Access Compliance Report

Public Rights-of-Way

Intersection ID: 26590	Main Street: PROVIDENCE_RD	Cross Street: COUNTRY_LN	Location: SW
ADA ID: 5610A80A823B	Ramp Type: PerpDiag	Initial Pass/Fail: Pass	Overall Compliance: No
		Severity Score: 10

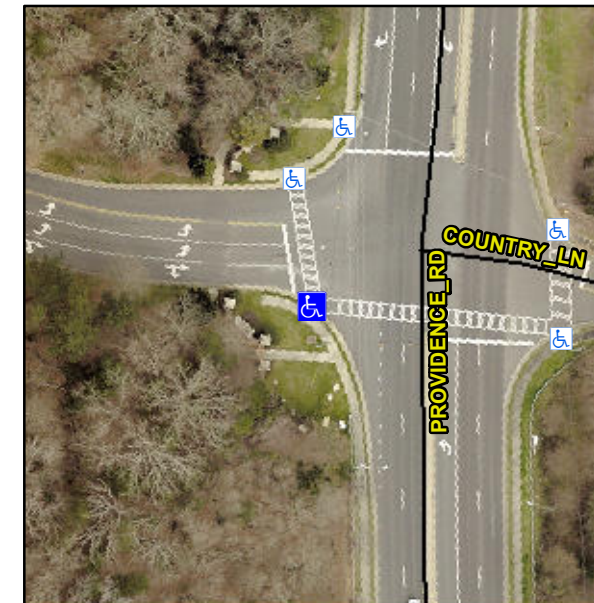
R304.2.1, R304.2.2-Perp, R304.3.2-Para, R304.5.3, R305.2

Compliance	Description	Data	Compliance	Description	Data
N/A	Ramp Length (in)	85.0	Yes	Ramp Slope (%)	6.3
Yes	Ramp Width (in)	48.5	Yes	Ramp XSlope (%)	0.7
N/A	Flare Type LT	Sloped	N/A	Flare Type RT	N/A
N/A	Flare Slope LT (%)	4.3	Yes	Flare Slope RT (%)	5.3
N/A	Flare Traversable LT?	Yes	N/A	Flare Traversable RT?	Yes
No	Landing Length (in)	N/A	Yes	DWS Provided?	Yes
No	Landing Width (in)	N/A	Yes	DWS Contrast?	Yes
No	Landing Slope (%)	N/A	Yes	DWS Length (in)	24.0
No	Landing X Slope (%)	N/A	Yes	DWS Full Width?	Yes
N/A	Landing Curb? (Y/N)	No	No	DWS Offset (in)	5.0
N/A	Shared Landing?	N/A			
Yes	Gutter Ponding?	No	Yes	Gutter Slope (%)	4.7
Yes	Gutter Lip Ht (in)	0.0	Yes	Gutter X Slope (%)	0.6
N/A	Painted X Walk1?	Yes	N/A	Painted X Walk2?	Yes
	X Walk 1 Direction	To SE		X Walk 2 Direction	To N
N/A	X Walk 1 Width (in)	78.5	N/A	X Walk 2 Width (in)	80.0
	X Walk 1 Slope (%)	2.1		X Walk 2 Slope (%)	3.9
	X Walk 1 X Slope (%)	2.6		X Walk 2 X Slope (%)	4.5

Yes	Ramp inside XWalk1?	Yes	Yes	Ramp inside XWalk2?	Yes
	Road Slope (%)	0.3	N/A	Clear Space?	Yes
	Road X Slope (%)	3.6	Yes	Clear Space to XWalk (in)	76.0
Yes	Any Obstructions?	No	Yes	Storm Grate/Utility Hazard?	No
	Obstruction Type			Storm Grate/Utility Type	
		N/A			N/A
			Yes	Surface Condition? (G/P)	Good

Remove & Replace Curb Ramp With Two New Directional Ramps or Equivalent.
